UNITED STATES PATENT AND TRADEMARK OFFICE

APPLICATION NO.	FILING DATE	FIRST NAMED INVENTOR	ATTORNEY DOCKET NO.	CONFIRMATION NO.
10/705,731	11/11/2003	Michael Collier	005127.00307	5000
22910 7590 01/30/2007 BANNER & WITCOFF, LTD. 28 STATE STREET 28th FLOOR BOSTON, MA 02109-9601			EXAMINER LARSON, JUSTIN MATTHEW	
			ART UNIT 3782	PAPER NUMBER
SHORTENED STATUTORY PERIOD OF RESPONSE			MAIL DATE	
3 MONTHS			01/30/2007	
			DELIVERY MODE PAPER

Office Action Summary

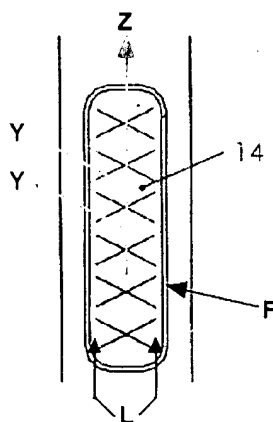
By forming gaps in the ends of the chambers (14) of Seven S.P.A as shown in the figure below, two longitudinal chambers (L, below) are effectively formed along the length of the bladder, wherein each transverse chamber is in fluid communication with both of the longitudinal chambers, each transverse chamber has a longitudinal axis (Y, below) parallel to the longitudinal axis of the other transverse chambers, and wherein the longitudinal axis (Y, below) of each transverse chamber is disposed at an acute angle with respect to a longitudinal axis (Z, below) of the bladder.

Regarding claim 2, the modified Seven S.P.A bladder includes a flange portion (F, above) surrounding the first and second longitudinal chambers.
